RECALL 21V172. 2021-143 REMEDY INSTRUCTIONS

Make(s): Clipper and Viking
Model(s): CWT182DBU & VWT182DBU
Model Year(s): 2021

Concern:
The manufacturing plant did not install nor seal the panel, which isolates the furnace from the cooktop.

FIGURE 2

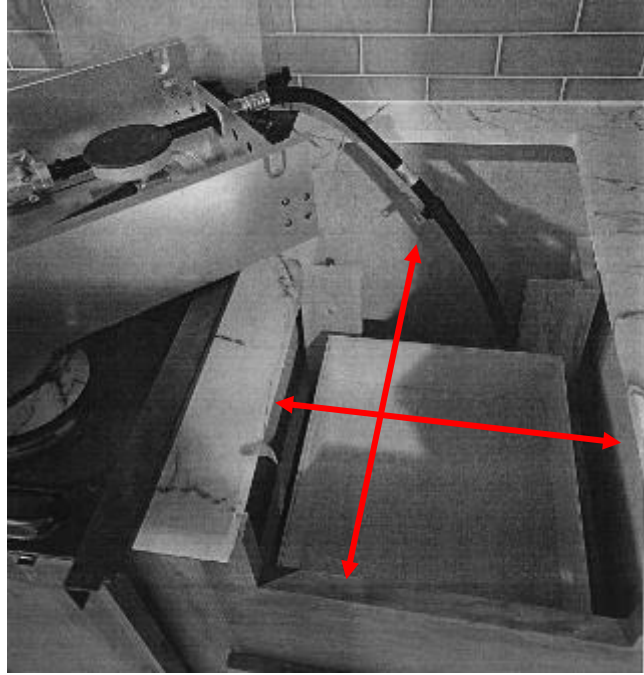
STEP 2: MEASURE THE FULL WIDTH AND DEPTH OF THE OPENING ABOVE THE DRAWER; (FIGURE 2)

- CUT A SINGLE PANEL THE SIZE THAT FITS THE OPENING (FIGURE 2)
- CUT THE PANEL IN HALF SO IT MAY BE INSTALLED EASIER (FIGURE 3)
- INSTALL CLETES TO PANELS "FRONT AND REAR" TO SCREW TO THE WALL (FIGURE 3)
- NOTCH ONE PANEL FOR THE LPG HOSE AND NOTCH FOR CABINET CLETES (FIGURE 3)
